# UNITED STATES PATENT AND TRADEMARK OFFICE

APPLICATION NO.	FILING DATE	FIRST NAMED INVENTOR	ATTORNEY DOCKET NO.	CONFIRMATION NO.
10/553,568	10/13/2005	Noelle Philippe	H0004973	1600
46507 7590 06/16/2008 HONEYWELL TURBO TECHNOLOGIES 23326 HAWTHORNE BOULEVARD, SUITE #200 TORRANCE, CA 90505				
EXAMINER				
TRIEU, THAI BA				
ART UNIT		PAPER NUMBER		
3748				
MAIL DATE		DELIVERY MODE		
06/16/2008		PAPER

# Office Action Summary

### **DETAILED ACTION**

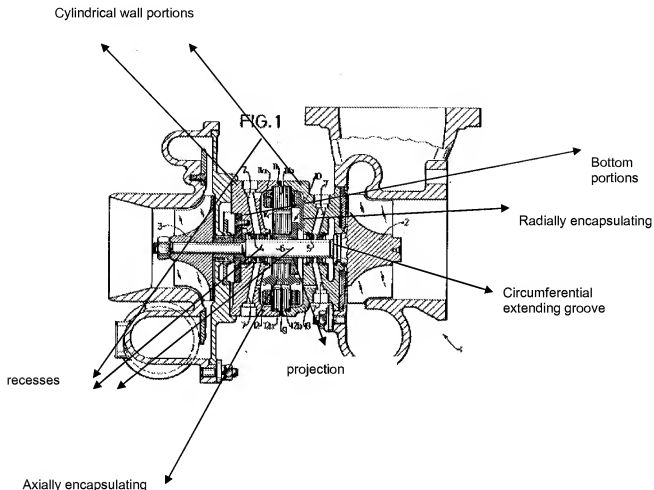
the electric motor (10) is accommodated in the center housing (12, 13)  
such that the electric motor (10) is firmly fixed by connecting the center housing  
(12, 13) to the compressor housing (Not Numbered) (See Figure 1);

wherein one of the cartridge housing portions (12, 13) serves as a seal plate on the journal bearing (4,5) side and the other cartridge housing portion (12, 13) serves as a backplate on the compressor wheel (3) side;

a motor housing (12, 13) for accommodating a shaft (6) and the electric motor (10), the shaft (6) serving as a rotor (9) of the electric motor (10) and carrying a compressor wheel (3); and a compressor housing (not Numbered) for accommodating the compressor wheel (3); wherein the electric motor (10) is accommodated in the motor housing (12, 13) such that the compressor motor (10) is firmly fixed by connecting the motor housing (12, 13) to the compressor housing (Not Numbered) (See Figure 1)..

The examiner respectfully disagrees, since Frister does disclose a stator is radially and axially encapsulated there between an assembled cartridge formed by two portions, which is shown in attached Figure 1.
